APPLICATION NO.	FILING DATE	FIRST NAMED INVENTOR	ATTORNEY DOCKET NO.	CONFIRMATION NO.
10/617,789	07/14/2003	Kazuto Hirokawa	2003-0960A	4090

Office Action Summary	Application No.	Applicant(s)	
	10/617,789	HIROKAWA ET AL.	
	Examiner	Art Unit	
	Hadi Shakeri	3723

DETAILED ACTION

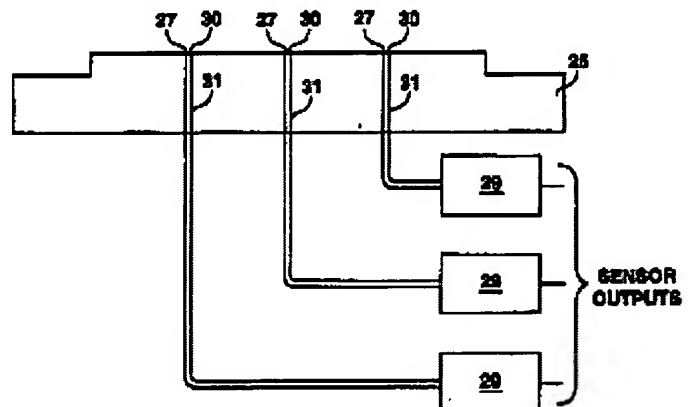
9. Claim 9 (as best understood) is rejected under 35 U.S.C. 102(b) as being anticipated by Pant et al. (5,762,536).

Pant et al. discloses all of the limitations of claim 9, as best understood, i.e., polishing apparatus comprising a polishing table (25) having polishing surface (12) against which a substrate is pressed, light emitting and light receiving devices (optical sensors 29, e.g., 05:57) and first and second passages (31) for introducing fluid through which light passes (e.g., 07:1-11), and a switching "device" for switching between the passages, i.e., (29) (35).

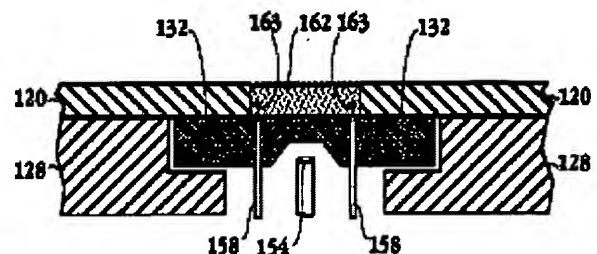
10. Claim 10 is rejected under 35 U.S.C. 102(e) as being anticipated by Boyd et al. (6,599,765).

Boyd et al. discloses all of the limitations of claim 10, i.e., polishing apparatus comprising a polishing table having polishing surface against which a substrate is pressed and a passage (134) to supply a fluid to said polishing surface on said polishing table, wherein said passage includes at least two passages (158), note the explanation above regarding narrative and/or functional language, i.e., each passage may supply high or low flow rate.
